Technical Note

Subject: Fonthill Road Corridor – Design Amendments Pre/Post Planning

Figure 1. Planning Layout – No Crossing Point

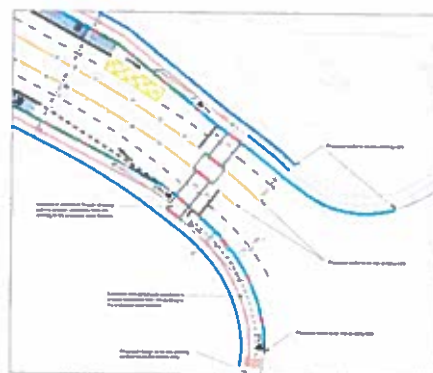
- 1.1. As one of the key objectives of the BusConnects guidance there is an emphasis on delivering safe cycling and pedestrian facilities along the corridor. As such, the proposed corridor from the outset included a number of toucan crossing points located at strategic areas of higher pedestrian/cyclist activity to cater for the envisaged movements to and from the Liffey Valley development and beyond to the wider road network.
- 1.2. The Stage 2 road safety audit undertaken for the design highlighted the issue of the transition between the existing bi-directional cycle provision at the southern tie in of the scheme and the proposed unidirectional cycle provision on both sides of the road along the corridor.

- 1.3. In order to overcome this conflict, the existing bi-directional cycle track was extended approximately 20m into the proposed scheme to tie in with a proposed new proposed toucan crossing beyond the north western exit from the existing roundabout. The rationale for inclusion of this design change was that this will remove ambiguity between the old/new cycle facilities and provide a needed connection from the single cycle track on the east side of Bóthar na Life to the existing bi-directional arrangement on the south west side.

Figure 6. Planning Layout – Inset Layby's (South)

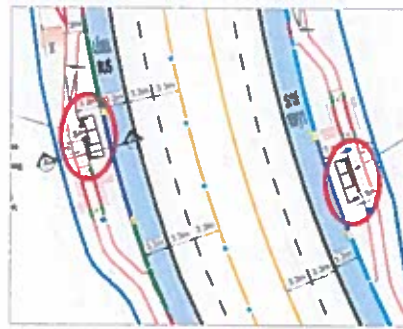
3.2. It should be noted that 2 no. new bus shelters are being proposed in this location (1 no. on each side of the road) as denoted on Figure 7 above. Each shelter shall include 1 no. mounted RTPI unit and 1 no. advertisement box and be as per JCDecaux drawings TEL-B653-SK-013A 'Reliance Shelter – 3 Bay Reliance Mark' included for information as part of the application drawing pack.

Figure 8. Planning Layout – Inset Layby (North)

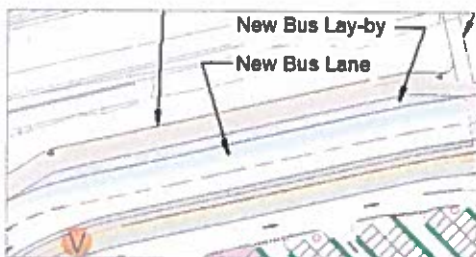
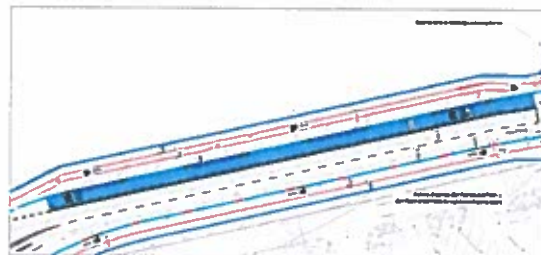
3.3. This type of 'in line' bus stop arrangement has also been replicated to the north of the shopping centre adjacent to the existing N4 footbridge as per Figures 8 and 9 below. The NTA however confirmed that this area is only intended as a 'set down' area for users exiting the buses and therefore will not require bus waiting areas/shelters.

Figure 10. Planning Layout – Existing Left Slip

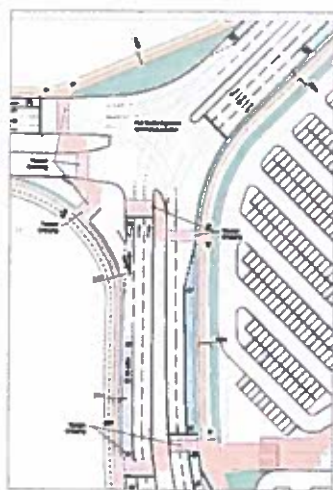
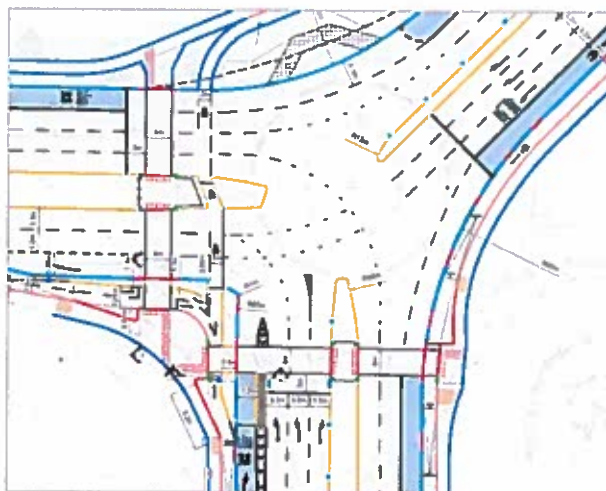
- 4.1. The original planning layout assumed retaining the existing segregated left slip lane on the southern arm of the proposed signal junction for vehicles wishing to travel westbound along Bóthar na Life. Following new design criteria set out within the BusConnects guidance document, the NTA requested that Systra undertake a review of bus priority at the signal junction in addition to removing the left slip lane.
- 4.2. Following a process of re-design of the southern arm of the junction in addition to further modelling work being undertaken to assess the optimum layout from a traffic perspective, the layout in its current format was accepted by the NTA and SDCC.
